Our Ref: 192933/6

Re: Lighting Strategy Review

CLIENT ESFA			
PROJECT THE HEIGHTS 106 WORKS			
TITLE 106 EXTERNAL LIGHTING			
DATE	11.03.19	SCALE	1:200 @ A0
DESIGNED	SS	CHECKED	IS
APPROVED	SS		
SUPPLY CODE	SUPPLY DESCRIPTION		
DRAWING STATUS FOR CONSTRUCTION			
DRAWING NO. FS0280-ELE-106-00-DR-EX-63001			
REVISION C03

TITLE
External Lighting Services Layout

KIER	
CLIENT ESFA	
PROJECT THE HEIGHTS 106 WORKS	
TITLE 106 EXTERNAL LIGHTING	
DATE 11.03.19	SCALE 1:200 @ A0
DESIGNED SS	CHECKED SS
SUITABILITY CODE 	SUITABILITY DESCRIPTION
DRAWING STATUS FOR CONSTRUCTION	
DRAWING No. FS0280-ELE-106-00-DR-EX-63001	REVISION C04

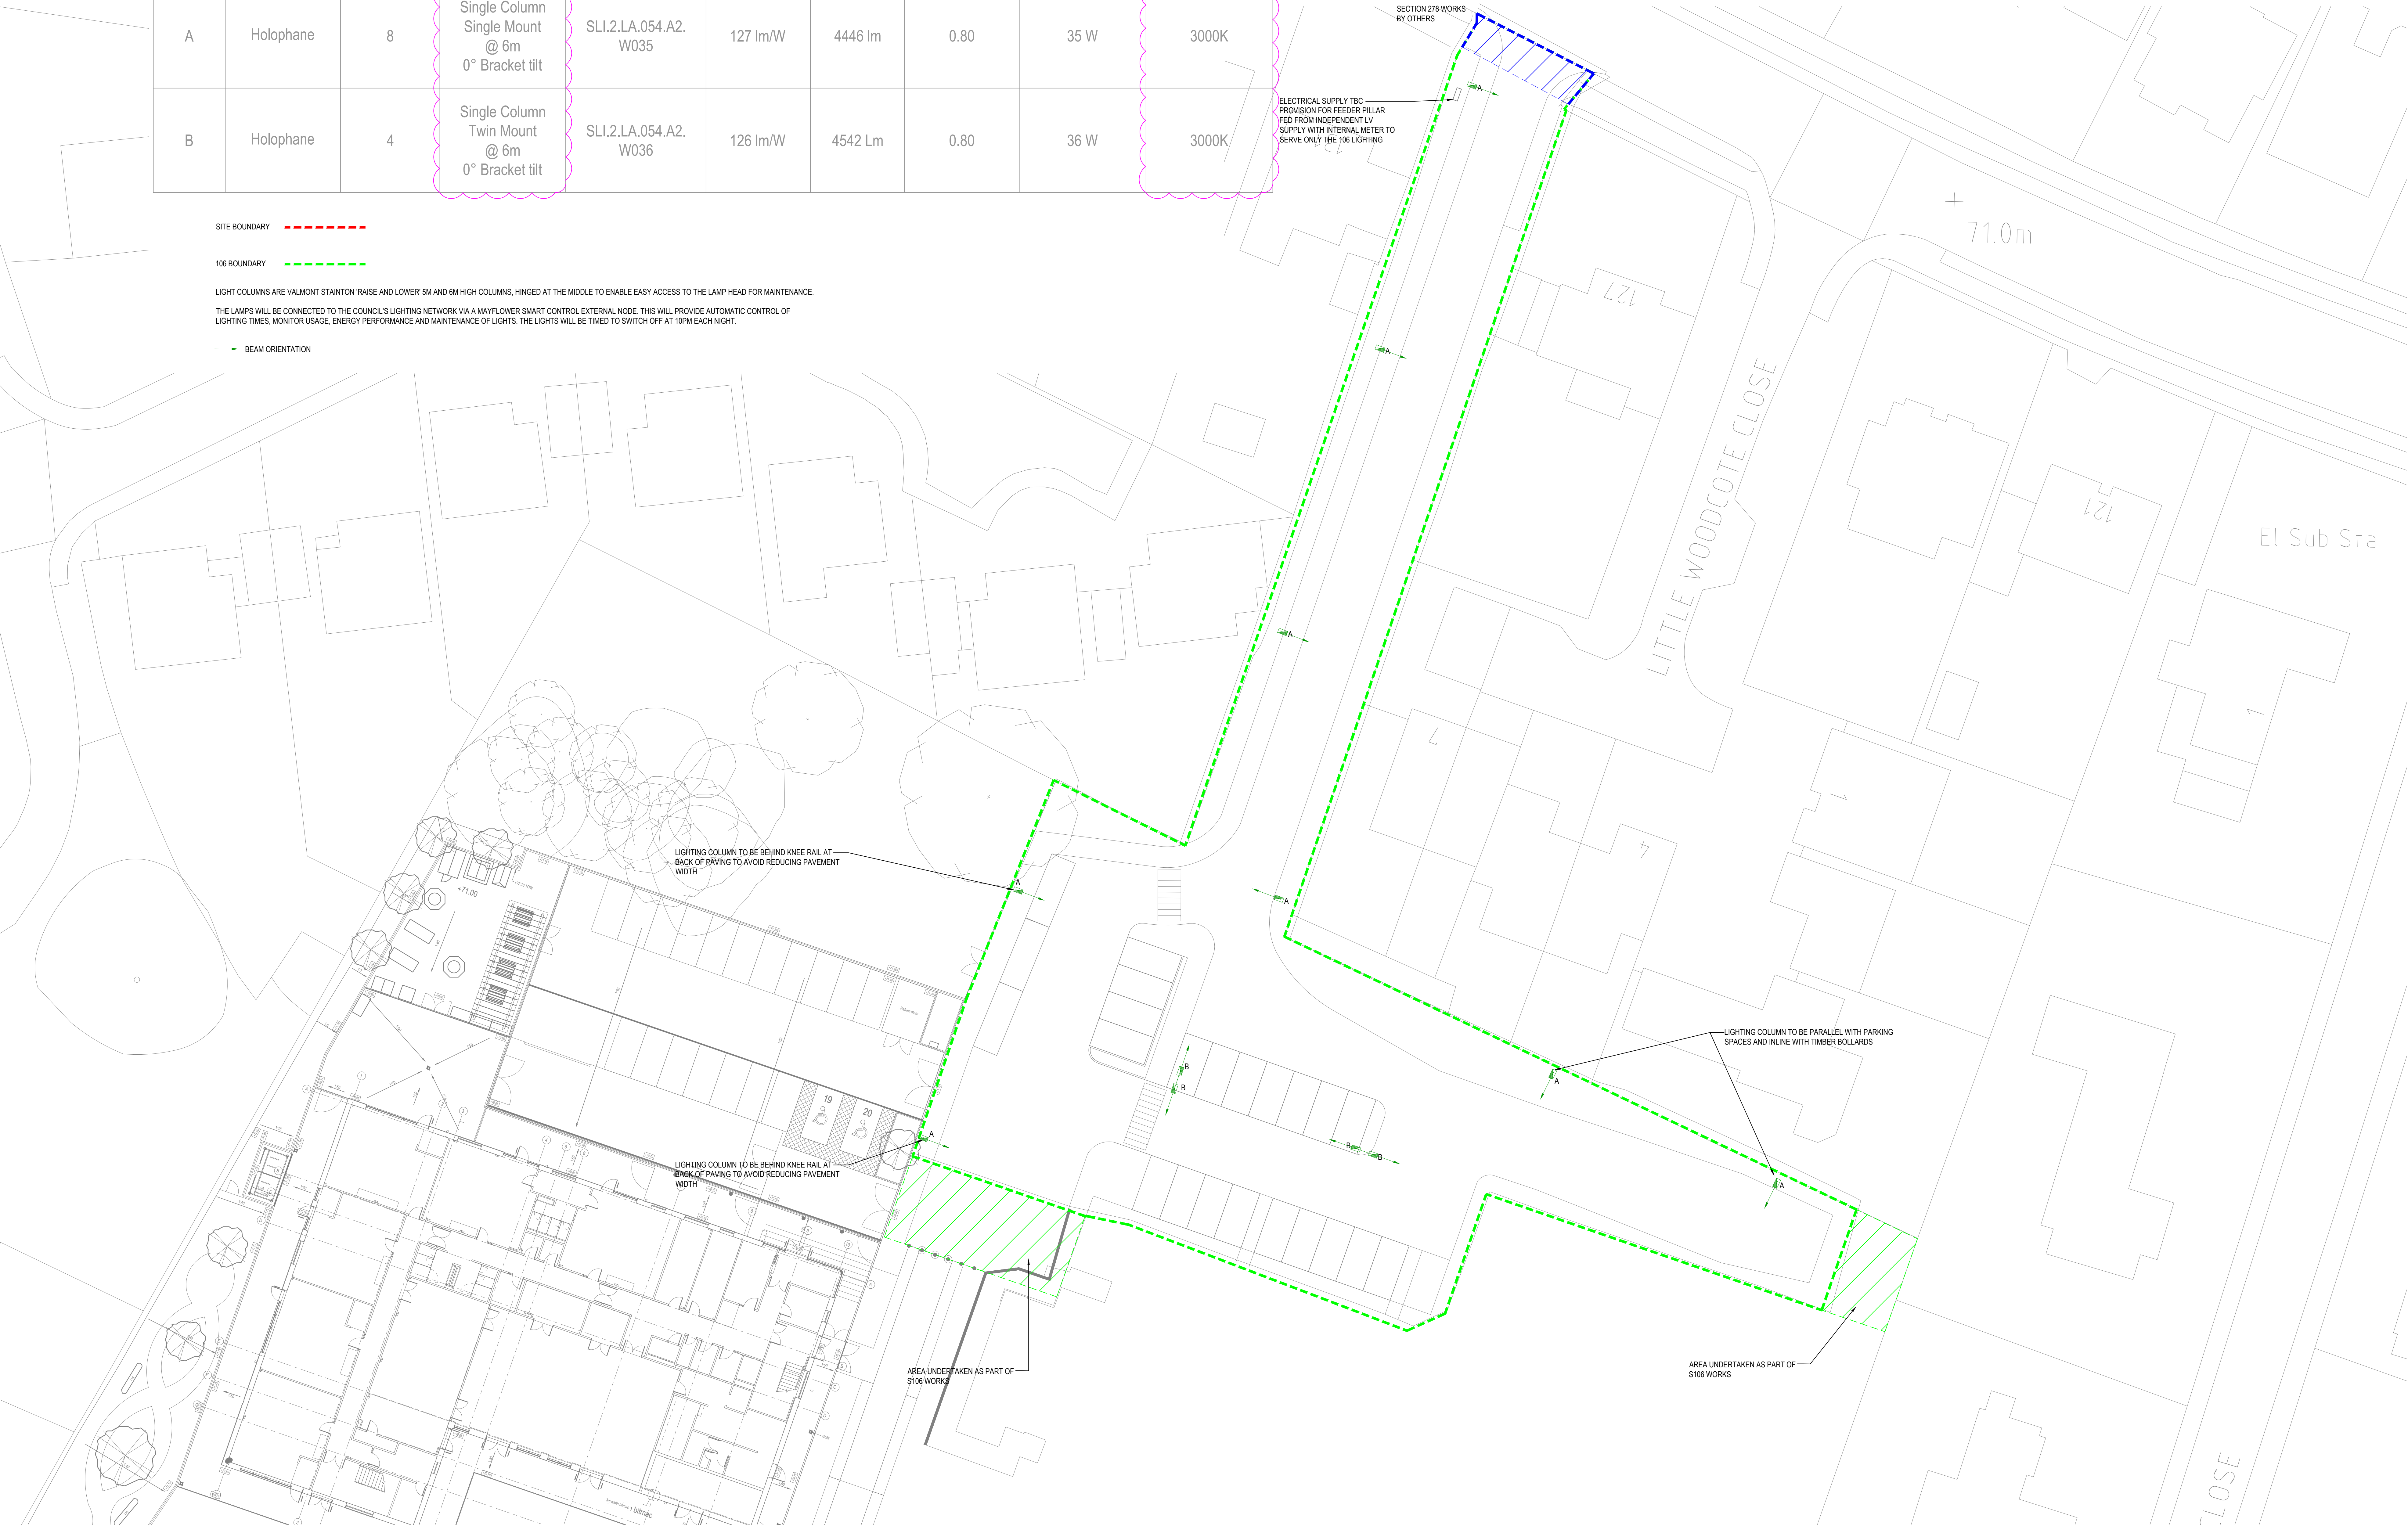
Keystone Ecology reviewed the existing lighting proposals and through liaison with Elementa Consulting the following changes were agreed to bring the proposals in line with current guidance for bats:

- 0° tilt implemented on all external lights
- Cowls and hoods have been added to reduce light spill.
- Column heights have been reduced
- Light spill onto ecological receptors (notably from the mixed use game area onto retained trees and landscaping to the west of site) has been reduced to background levels for the area with little or no vertical spill.
- A reduction in colour temperature to 3000 Kelvin site wide (a slightly higher temperature was acceptable due to the lower light spill)

CHANGE TO 0 DEGREE TILT

CHANGE TO LOWER COLOUR TEMPERATURE

Luminaire parts list									
Index	Manufacturer	Quantity	Luminaire type	Item number	Luminaire efficacy	Luminous flux	Maintenance factor	Connected load	Notes
A	Holophane	8	Single Column Single Mount @ 6m 0° Bracket tilt	SLI.2.LA.054.A2. W035	127 lm/W	4446 lm	0.80	35 W	3000K
B	Holophane	4	Single Column Twin Mount @ 6m 0° Bracket tilt	SLI.2.LA.054.A2. W036	126 lm/W	4542 Lm	0.80	36 W	3000K

A0 ORIGINAL SIZE DRAWING			
C01	Changes to meet ecology requirements	SS	29.11.19
C03	BEAM ORIENTATION	SS	04.09.19
C02	UPDATED TO SUIT CIVIL'S LAYOUT	IS	04.07.19
Elementa Consulting Ltd 99 Park Drive London Didcot, Oxfordshire OX14 4RY t: +44(0)1235 620300 www.elementaconsulting.com			
elementa Member of Integral Group
